10 July 2018

ASICS FACILITY, SYDNEY BUSINESS PARK (SSD 9153) – RESPONSE TO SUBMISSIONS

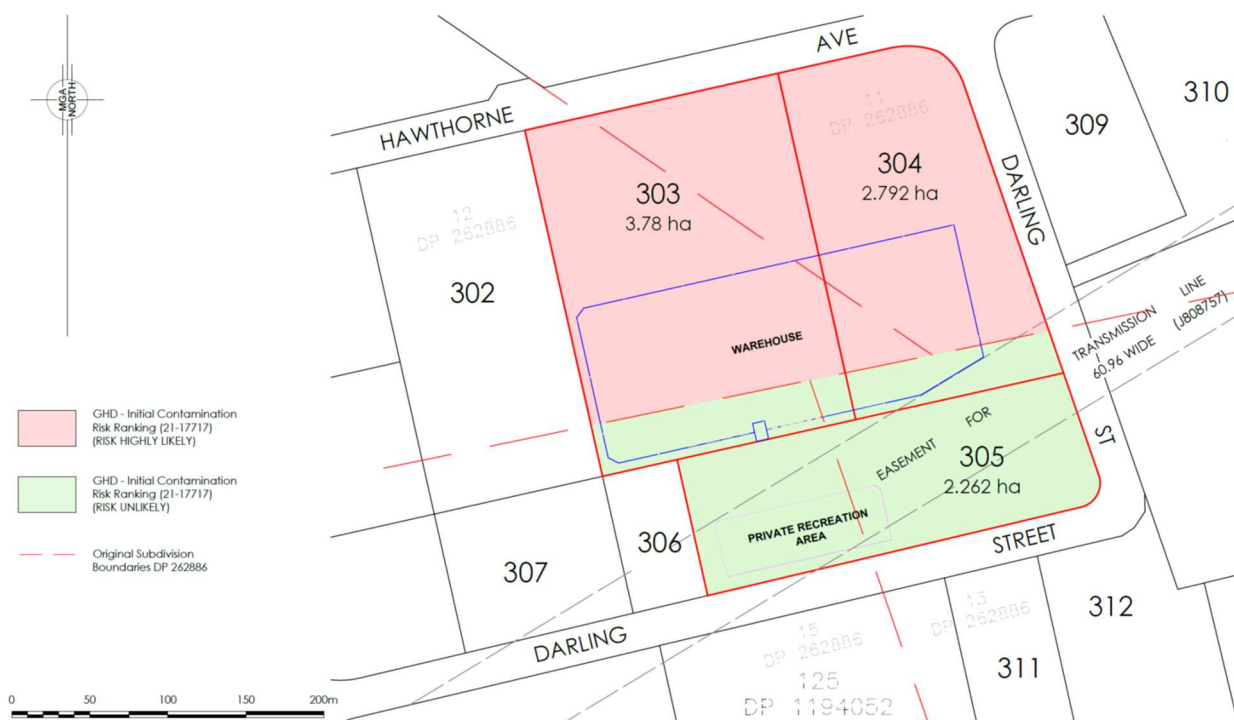
| Aspect | Issue/Recommendation | Response |
|------------|--|---|
| | Confirm that additional potential provision of on-site parking in the landscape area or on the sports field is feasible given the constraints associated with the Transgrid easement | <p>An amended concept plan demonstrating that additional parking could be provided on site to meet the DCP requirements is provided on Figure 2 below.</p> <p>As outlined in the EIS, it is noted that any future land use that required additional car parking spaces would be subject to separate development consent. Assessment of car parking requirements associated with such a development would be assessed on its merits at that time.</p> |

| Aspect | Issue/Recommendation | Response |
|--|---|--|
| <i>Car Parking</i> | Please review the site layout with the view of providing at least 252 car parking spaces | <p>The design plans have been amended to provide 248 car parking spaces, which is an increase of 5 spaces from that outlined in the EIS (see Appendix A).</p> <p>Increasing car parking capacity beyond 248 spaces was found not to be practicable without significantly affecting the layout and/or landscaping areas of the site, and given the constraints associated with the Transgrid easement.</p> <p>Further, the proposed parking supply is considered to be more than adequate to accommodate the parking demand associated with the proposed development.</p> <p>In this regard, it is noted that the Department's calculations (in Table 1 of its additional information request) are based on gross floor areas, without any allowance for GFA exclusions or</p> |

| Aspect | Issue/Recommendation | Response |
|--------|---|--|
| | | <p>back-of-house areas in the showroom and retail outlet. The calculations in Table 6.3 of the EIS were also conservatively based on these gross areas.</p> <p>With regard to the showroom and retail outlet, if the back-of-house area (250m²) is calculated as warehouse space rather than retail space, then outlet would require some 58 spaces using the rates in the Department's calculations (as opposed to the Department's calculation of 68 spaces). It is noted that this figure (58 spaces) is still considered excessive for a standalone showroom/retail outlet in an industrial area. As outlined in the EIS, additional on-site parking for the showroom and retail outlet would be available on weekends (ie. during peak times) when fewer warehouse and office staff are on site.</p> <p>With regard to the office and warehouse, it is noted that the office area comprises some 160m² of allowable GFA exclusions (ie. lifts, stairs, voids and plant), and the warehouse comprises some 3,000m² of further GFA exclusions (ie. the staging/loading areas). If these were considered, the required parking supply would reduce by a further 14 spaces, or a requirement of 232 spaces in total for the ASICS Facility.</p> <p>As outlined in the EIS, the proposed parking supply is based primarily on a conservative estimate of the expected parking demand for the facility, rather than strict compliance with parking rates. This is considered appropriate given the mixed use nature of the proposal.</p> |
